Public Works Department – Engineering Division

ADDENDUM NO. 1

PROJECT 2019 BART PEDESTRIAN AND BIKE CONNECTIVITY

LEGEND: DEMOLITION PLAN (SHEETS DM-1 TO DM-8 ONLY)

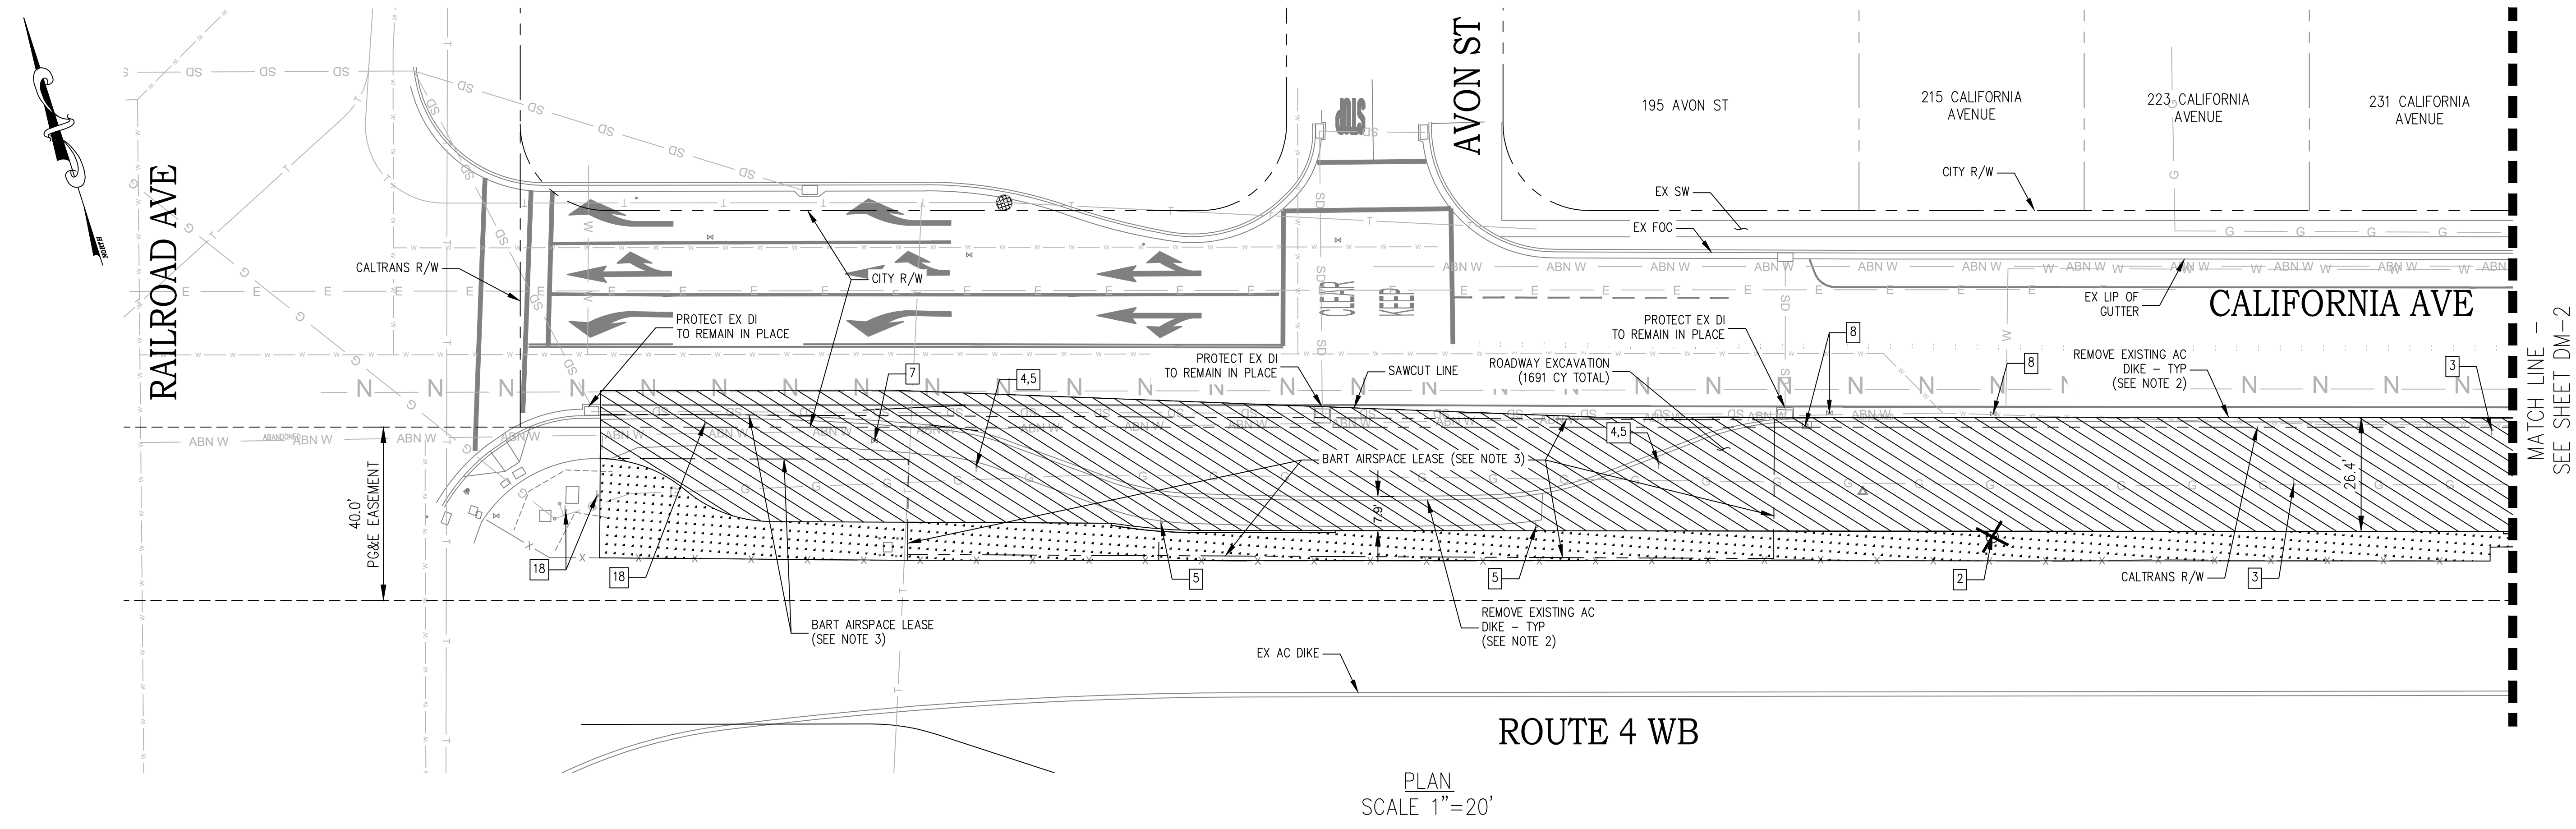
2. The demolition plan limits (specifically DM-1 and DM-4) do not match the layout plan limits (L-1 & L-4).?? If you were to overlay the two plans, it would show additional demolition/roadway excavation that would be needed in order to construct the new improvements that are not shown on the demolition plans.?? Since, roadway excavation is a final pay item, please clarify if bidders are to

Since, roadway excavation is a final pay item, please clarify if bidders are to follow the demolition plan limits or should demolition be based on the new improvement layout plans?

Correct, the demolition plan limits are shown incorrectly on sheets DM-1. See attachment B for revised demolition sheets.
